Docket Number:	17-AAER-06
Project Title:	Commercial and Industrial Fans & Blowers
TN #:	224812
Document Title:	AHRI Comments – Title 20 Pre-Rulemaking – June 2018 Draft Staff Report – Commercial and Industrial Fans & Blowers
Description:	N/A
Filer:	System
Organization:	AHRI/Laura Petrillo-Groh
Submitter Role:	Public
Submission Date:	9/28/2018 1:42:16 PM
Docketed Date:	9/28/2018

AHRI Comments “ Title 20 Pre-Rulemaking “ June 2018 Draft Staff Report “ Commercial and Industrial Fans & Blowers

Re: AHRI Comments – Title 20 Pre-Rulemaking – June 2018 Draft Staff Report –
Commercial and Industrial Fans & Blowers [*Docket No. 17-AAER-06*]

Figure 1: Condenser Fan Operating Characteristics

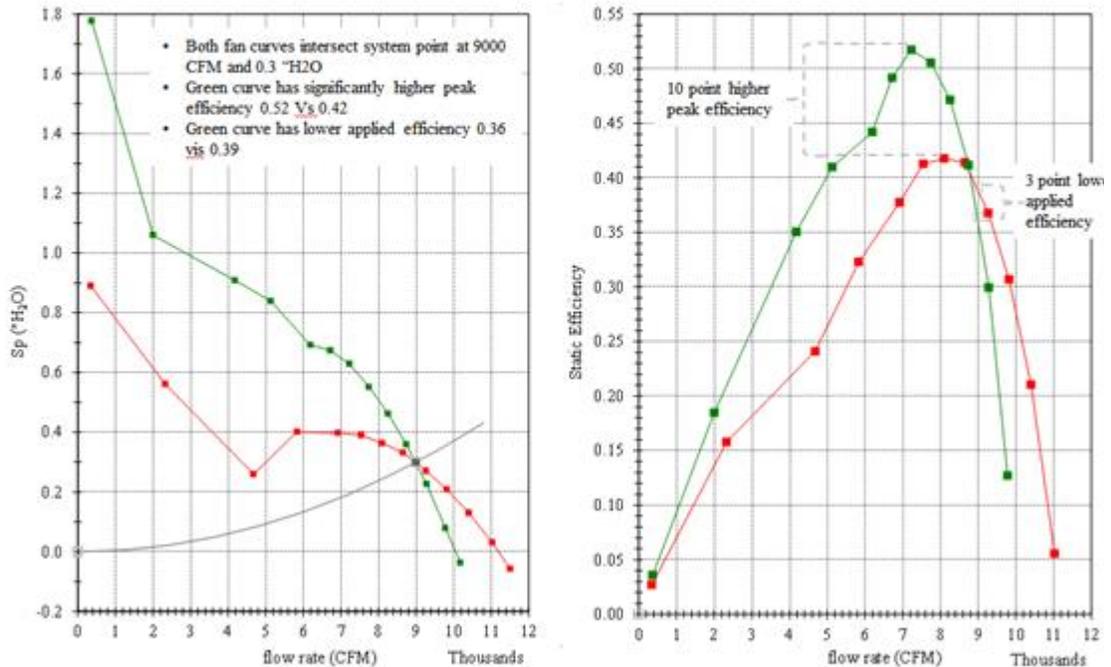
A “more efficient” fan may not yield a more efficient unit if the fan curve performance does not meet the likely operating conditions. In a specific example, there may be a “higher efficiency” fan that does not work as well as the lower efficiency fan in a specific condenser fan application because of where the fan actually operates. In the below figure, the red fan offers better performance relative to the green fan, even though the green fan has a peak efficiency well above the red one. The fan operates based on flowrate and static pressure and, in this case, the red fan is the better fan. This specific example indicates that the designer needs to be extremely careful in applying embedded fans into a product (Figure 1).

Figure 2: Reported US Shipments of Central Station Air-handling Units

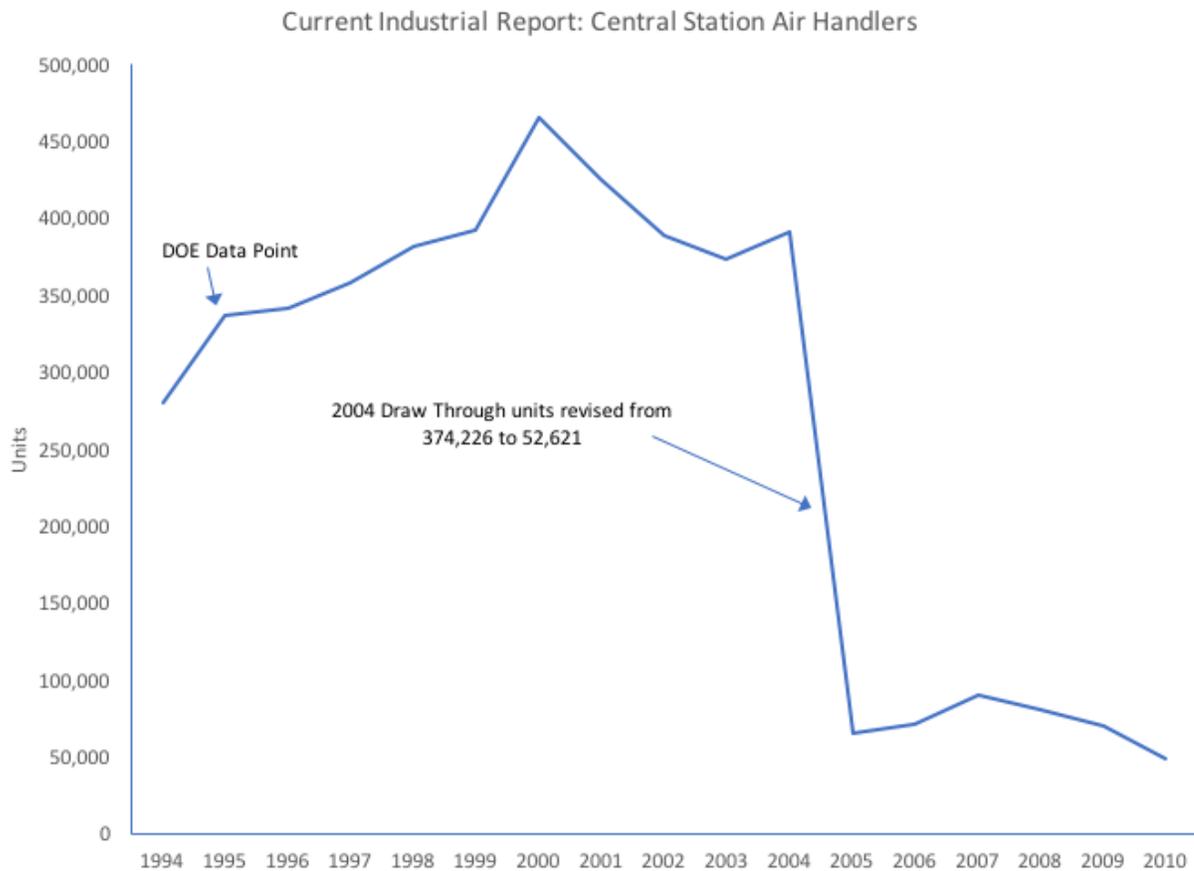
Department of Energy by Arthur D. Little, Inc.) which, in turn, relied on data from the US Department of Commerce, Census Bureau, Current Industrial Reports MA35M (CIR) for 1995. Arthur D. Little correctly used the data presented at that time in the CIR. However, there seems to have been a reporting error for product code 35851-13 central station air-handling units (motor driven fan type) – draw through, reported as 315,723 units in 1995, the year referenced by Arthur D. Little. This product category was revised for 2004 and subsequent years in the CIR for 2005, with 2004 shipments for that product code (now 3334151117) reduced from 374,226 to 52,621. The shipments for total central station air-handling units remained in the range of 48,000 to 90,000 units until 2015, when the CIRs were discontinued (Figure 2). AHRI collects but does not make public shipment data for central station air-handling units and the AHRI data is consistent with shipments in the high tens of thousands of units per year.

The revised central station air-handling unit estimate of 0.58 quads nationally and 0.07 quads in California overstates the actual potential savings that would occur through a fan standard. Fans used in central station air-handling units are subject to the total fan power limitations of Title 24, Section 104.4 (c) for units used in new construction and renovation. These restrictions put substantial pressure on building designers to limit fan energy use and the effects of these limitations are not adequately captured in the Base Case efficiency assumptions in the DOE models, which are built around national averages where the full effect of the ASHRAE 90.1 standards (implicit in the Title 24 limitations) do not occur as other states do not update building standards as diligently as California.

The FEI Paradox

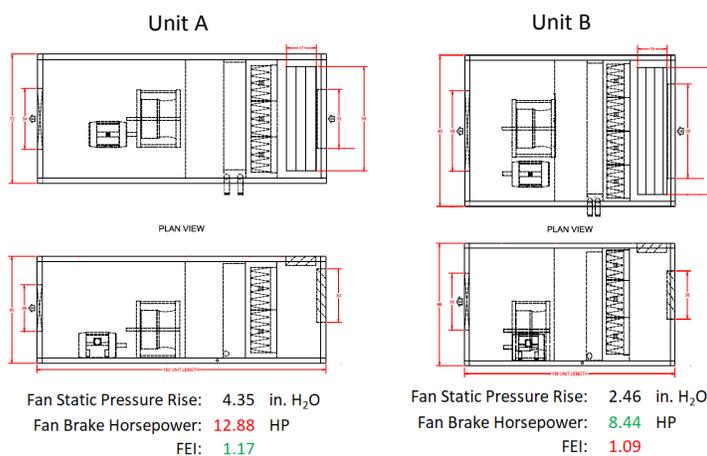
- Only #1 yields improved FEI.
- Add a variable speed drive (#2), and wire-to-air efficiency drops, yielding a lower FEI.
- Reducing pressure drop for a given fan system usually reduces FEI. See the illustration at right and on the next page.

Lower AHU power consumption yields lower FEI

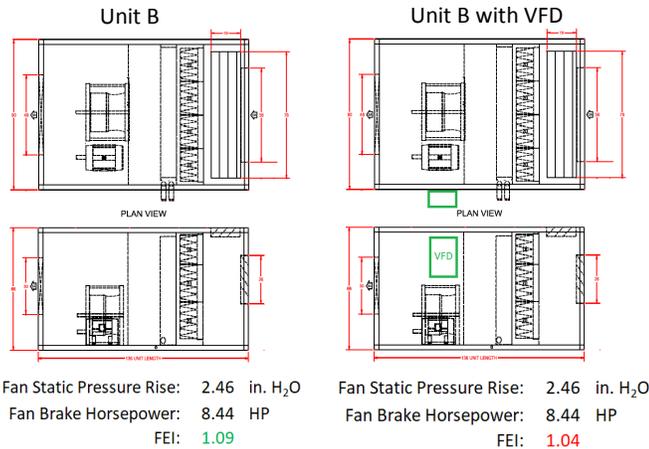
Two air handlers, with identical fans, motors and transmissions

Each has identical performance except for the fan brake horsepower at the design point:

- 12,000 SCFM
- 80°F db / 67°F db mixed air entering the coil
- 53°F db / 52.9°F db leaving the coil
- MERV-8 pre-filter
- MERV-13 high-efficiency filter
- 24.5" v-belt drive plenum fan
- 15 HP NEMA General Purpose Motor
- Rated with 1.0" external static pressure
